TRANS/WP.29/1998/58

PROPOSAL FOR DRAFT SUPPLEMENT 9 TO THE 04 SERIES OF AMENDMENTS TO REGULATION No. 16

(Safety-belts)

Transmitted by the Working Party on Passive Safety (GRSP)

Insert a new example of an approval mark, to read:

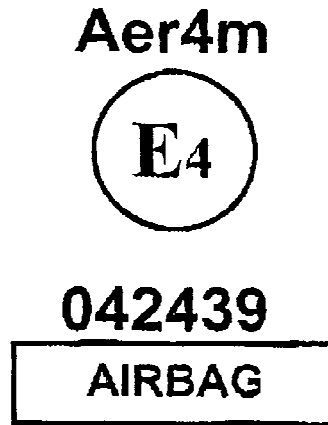
Annex 2,

The safety-belt bearing this type-approval mark is a three-point belt ("A") fitted with an energy absorber ("e"), approved as meeting the specific requirements of paragraph 6.4.1.3.3. of this Regulation, and with a multiple-sensitivity ("m") type 4 ("r4") retractor, in respect of which type-approval was granted in the Netherlands ("E4") under the approval number 042439. The first two digits indicate that the Regulation already incorporated the 04 series of amendments at the time of the approval. This safety-belt has to be fitted to a vehicle equipped with an airbag in the given seating position."
